## **BCA ASSESSMENT REPORT**

### **Oakdale East Estate, Kemps Creek Brickworks Warehouse 1 Extension**

**Prepared For:  
Goodman Property Services Pty Ltd**

Blackett Maguire + Goldsmith Pty Ltd (BM+G) have been commissioned by Goodman Property Services Pty Ltd to undertake a preliminary review of the proposed extension to the existing Precinct 1 Warehouse 1 Building, against the deemed-to-satisfy (DTS) provisions of the Building Code of Australia 2019 Amendment 1 (BCA) pursuant to the provisions of Clause 19 of the *Environmental Planning & Assessment Regulation (Development Certification & Fire Safety) 2021* and Clause 18 of the *Building Professionals Regulation 2007*.

Figure 1 – Warehouse 1 Perimeter Vehicular Access per BCA C2.4

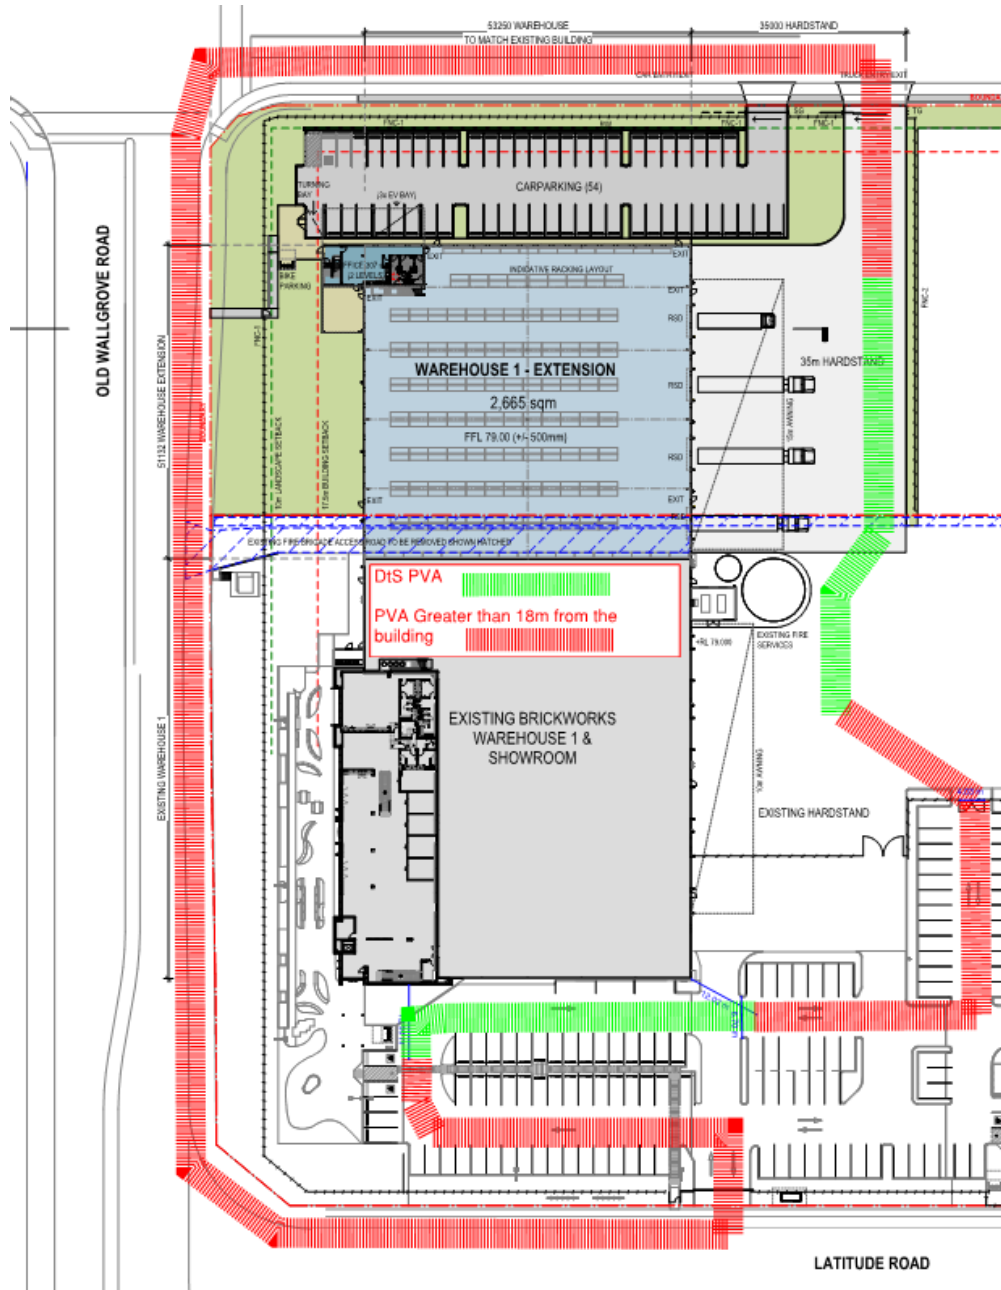
*Comments: The existing warehouse building is subject to a Performance Solution for perimeter vehicular access being greater than 18m from the external walls of the Southern and Western perimeters and perimeter vehicular access being less than 6m on the Northern end of the building (as documented in the Core FER). The following non-compliances have been identified as a result of the proposed warehouse extension and will be required to be addressed / updated in the Fire Engineering Report:*

- *The furthest part of the vehicular access path is greater than 18m from the external wall at the Northern and Western ends of the building along Estate Road 3 and Old Wallgrove Road respectively.*

- The furthest part of the vehicular access path is greater than 18m from the external wall at the Southern and South Eastern ends of the building along Latitude Road and the carpark between Warehouse 1 and the Masonry plant respectively.

Note 1: The driveways providing vehicular perimeter access must be designed with adequate loading capacities to withstand a fire truck and the gradients of the ramps should take into consideration to the FRNSW Policy 4 Vehicular Access Guideline.

Note 2: If the perimeter access paths are reduced to less than 6m in width to accommodate pedestrian egress paths per Clause D1.10 below, this will need to be documented in the Performance Solution.
